SITE PLAN

for : R. L. Moore Homes
CLIENT
7121 Revenna Road Concord Ohio 44077
ADDRESS CITY STATE ZIP

134 Cedar Glen
SUBLOT No. SUBDIVISION NAME VOL. PAGE
Painsville Ohio
LOT TRACT CITY STATE

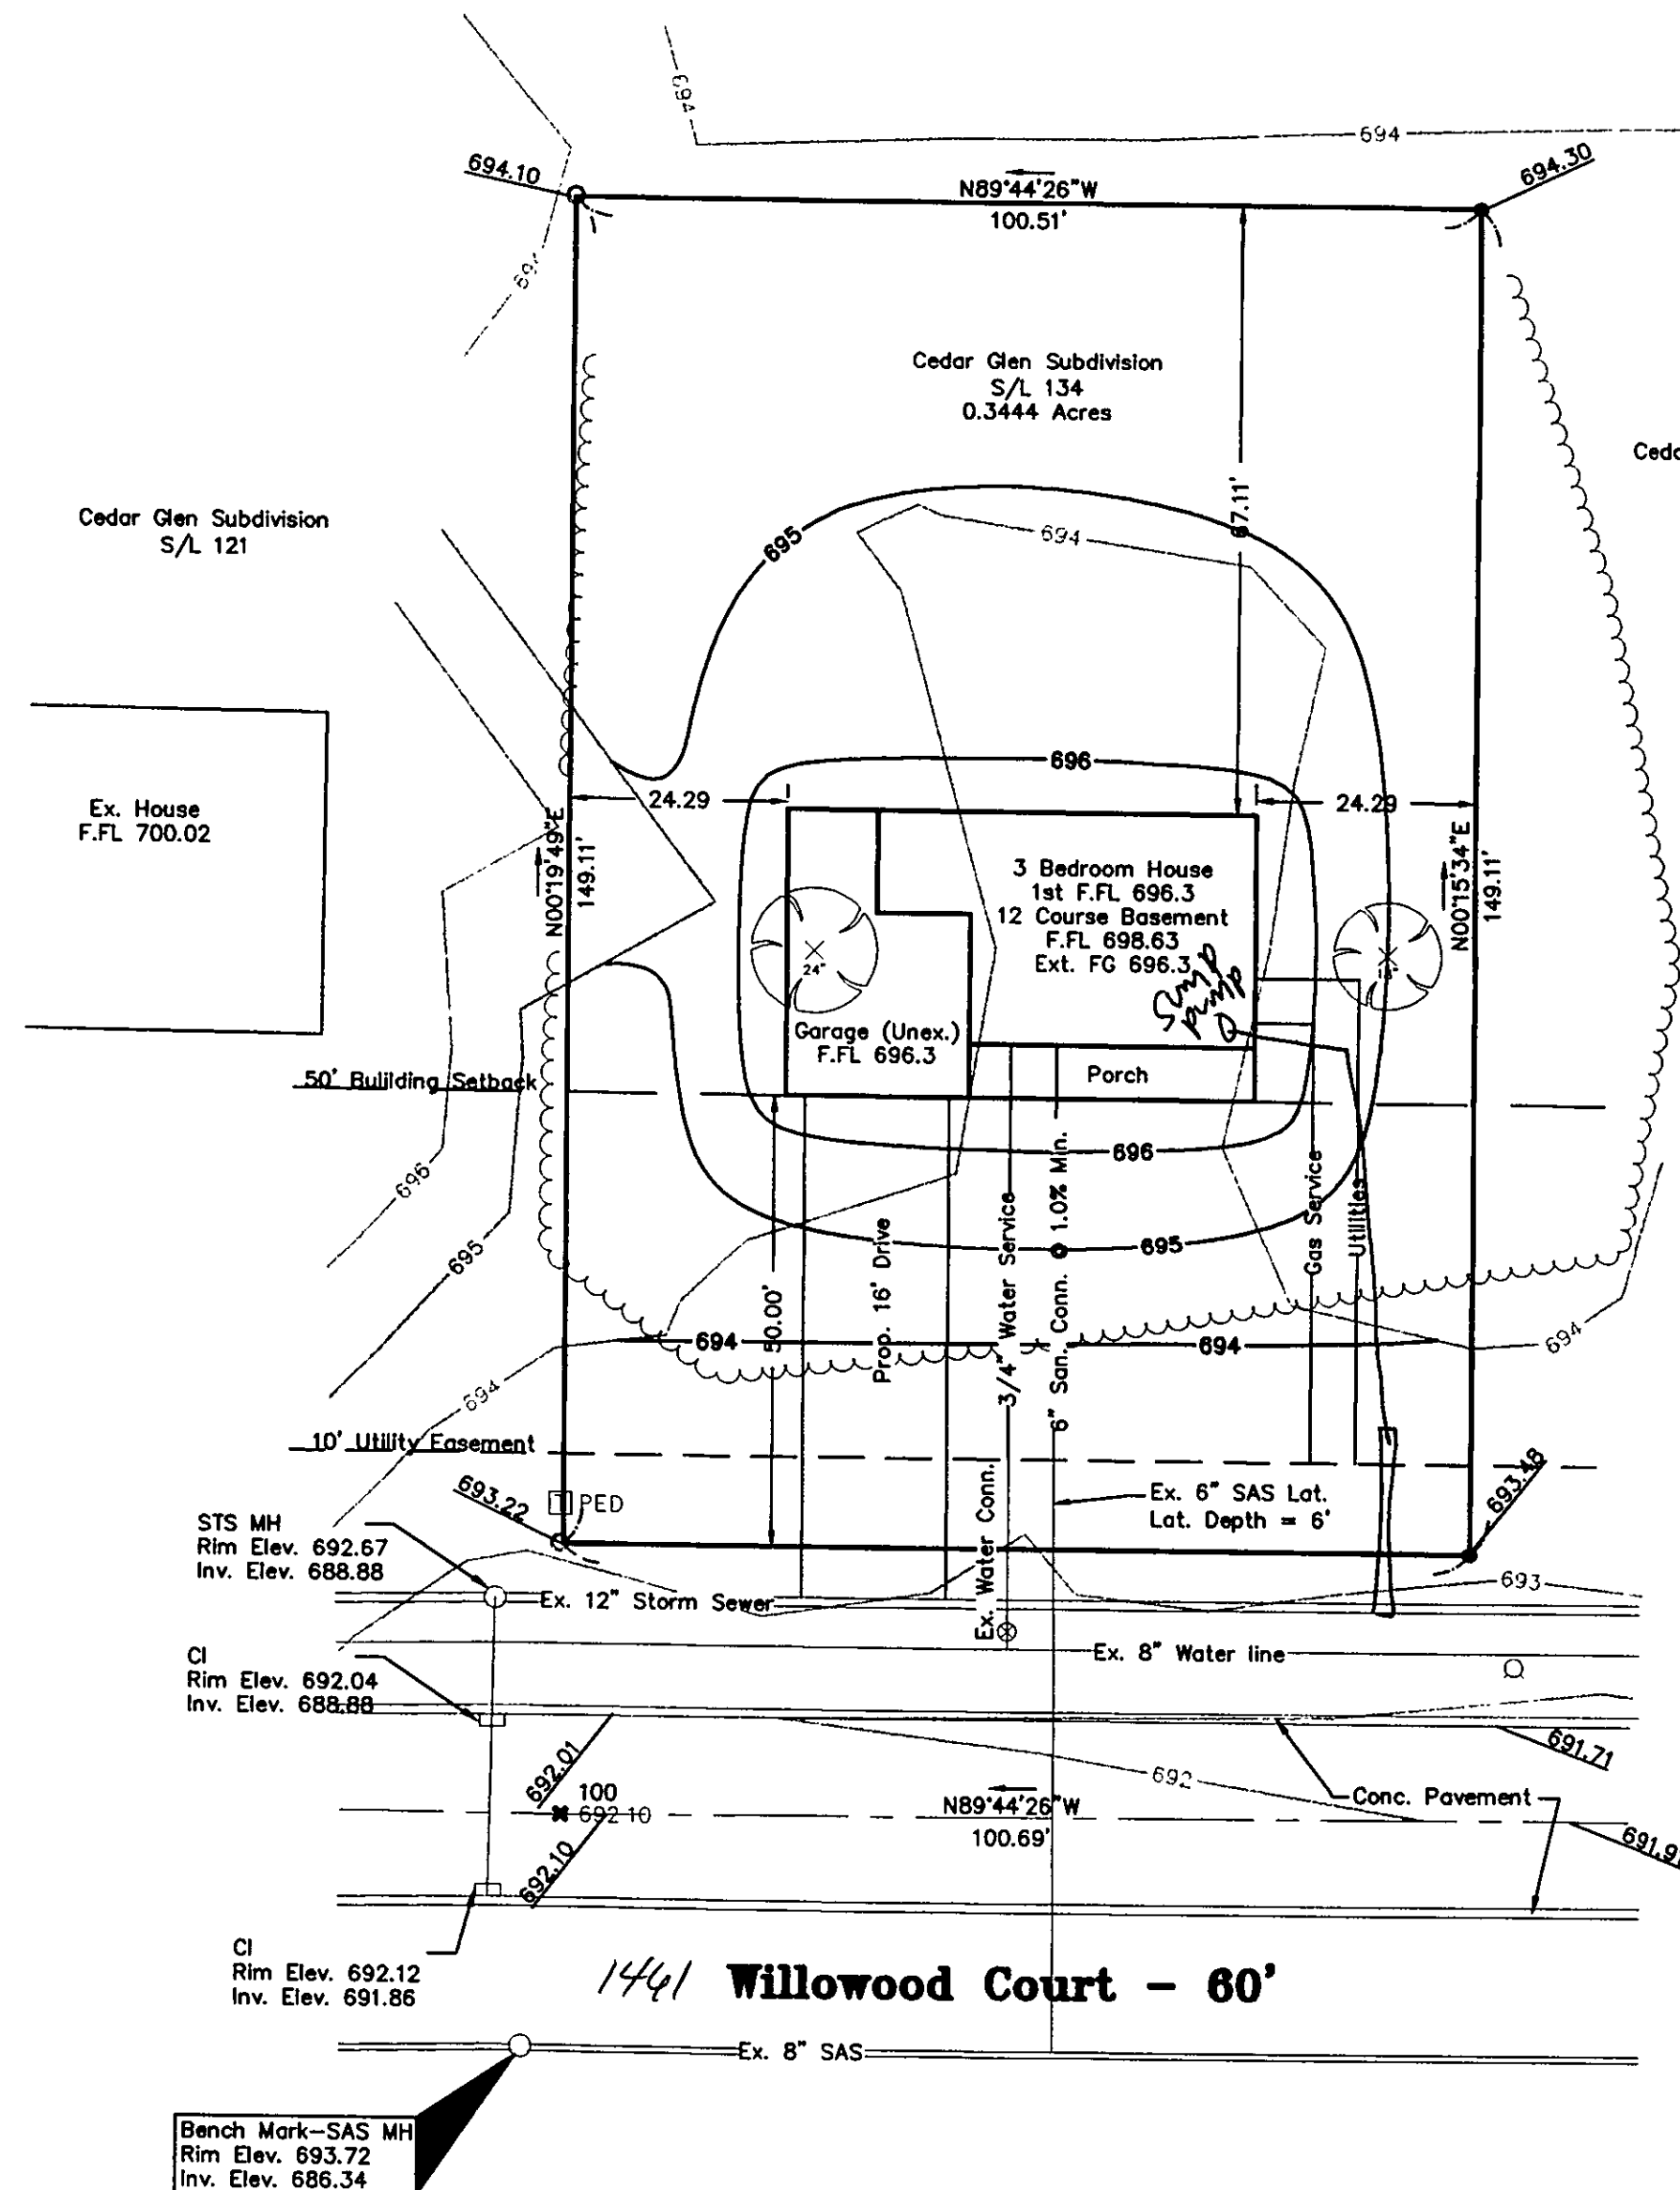
Grading Plan Approved
as shown and/or noted
T. MAS P. GILLES, P.E.
Lanc County Engineer

Discharge Sump pump
to Stm. lateral
